ACCESSION NBR: 7906200356 DOC. DATE: 79/06/15 NOTARIZED: NO DOCKET #
 FACIL: 50-261 H. B. Robinson Plant, Unit 2, Carolina Power and Light 05000261
 AUTH. NAME AUTHOR AFFILIATION
 UTLEY, E.E. Carolina Power & Light Co.
 RECIP. NAME RECIPIENT AFFILIATION
 SCHWENCER, A. Operating Reactors Branch 1

SUBJECT: Forwards addl info re facility requested 790521. Info is to be used to prepare basis for continued plant operation in light of TMI-2 event.

H. B. ROBINSON STEAM ELECTRIC PLANT, UNIT NO. 2
DOCKET NO. 50-26L
LICENSE NO. DPR-23
ADDITIONAL INFORMATION ON H. B. ROBINSON SYSTEMS

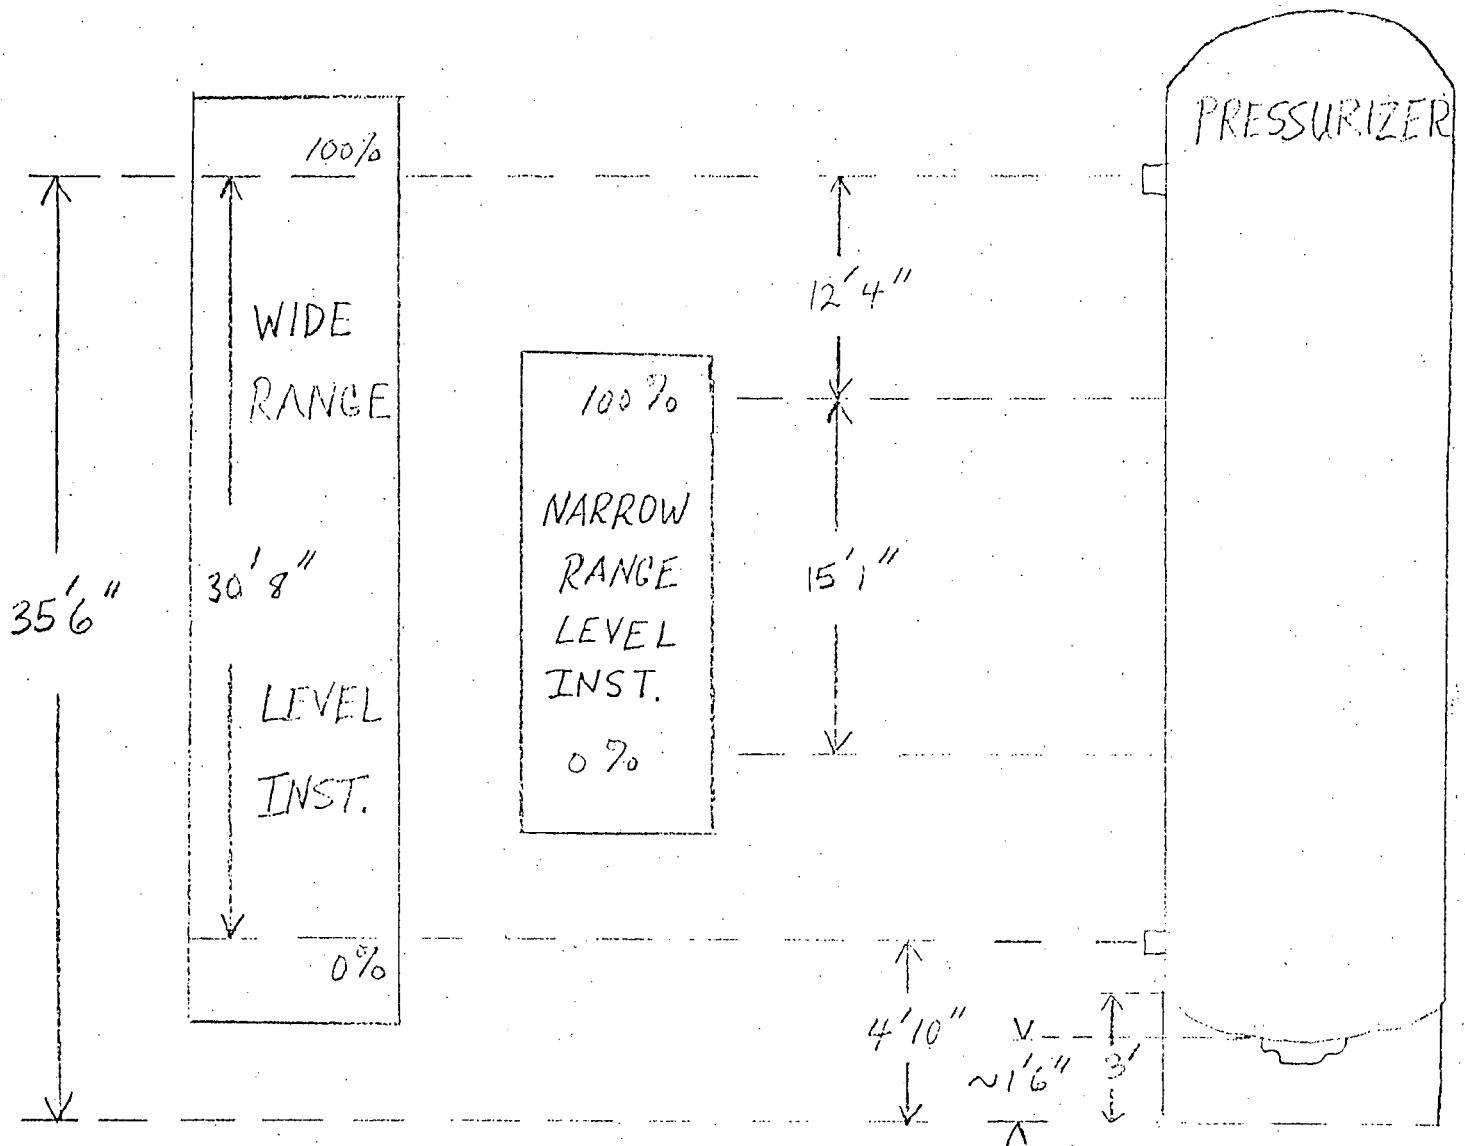
3. Identify the essential lines penetrating the containment; i.e., lines which do not have a post-accident safety function yet are important to plant safety. These lines typically do not receive an automatic isolation signal, or, if they do, their isolation is deferred until subsequent signals are received that confirm the existence of an accident condition. Describe and justify the isolation actuation provisions for these lines. (Exclude lines associated with the engineered safety features, and lines which are normally closed during operating modes requiring containment integrity and remain closed following an accident).

For additional support, the following information is provided:

Automatic isolation is not provided for some lines that are connected to non-radioactive systems outside the containment and in which a pressure gradient exists which opposes leakage from the containment.

These lines include the N₂ supply to the RCDT and to the PRT. These lines are manually operated, (see EI-1), after an accident.

Phase B isolation generated by a "P" signal isolates certain essential lines as listed in EI-1 and in the Reactor Safeguards System description.

Manual containment isolation is provided for certain essential lines which are normally filled with water and will remain filled following an accident. Isolation valve seal water is also supplied to these valves. These lines will remain in service until such time that they are no longer required. These lines include the Reactor Coolant pump seal water supply lines and the RCS charging line.
